# SERVICE BULLETIN

DATE: July 1, 2003 Service Bulletin No. 543B  
(Supersedes Service Bulletin No. 543A and  
Supplement No. 1 to Service Bulletin No. 543A)

SUBJECT: Oil Filter Converter Plate Gasket Replacement

Figure 1.

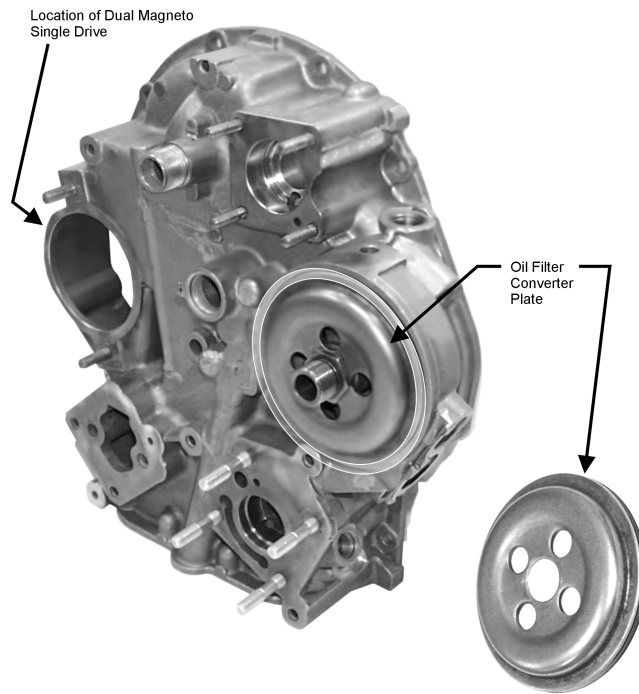
Lycoming has determined that some P/N LW-13388 oil filter converter plate gaskets were made from incorrect material. This could cause some converter plate gaskets to become extruded from the seat, allowing oil to leak out between the plate and the accessory housing.

1. Remove the oil filter and the converter plate (Figure 1). Remove the gasket from the plate in accordance with the latest revision of Lycoming Service Instruction No. 1453.

2. Replace the P/N LW -13388 gasket with a new gasket P/N 06B23072 in accordance with the latest revision of Lycoming Service Instruction No. 1453. For identification, new gaskets P/N 06B23072 have been stamped with their part number.
3. After bonding the P/N 06B23072 gasket in place, vibropeen the number 543 anywhere along the outer surface of the plate flange as shown in Figure 2.
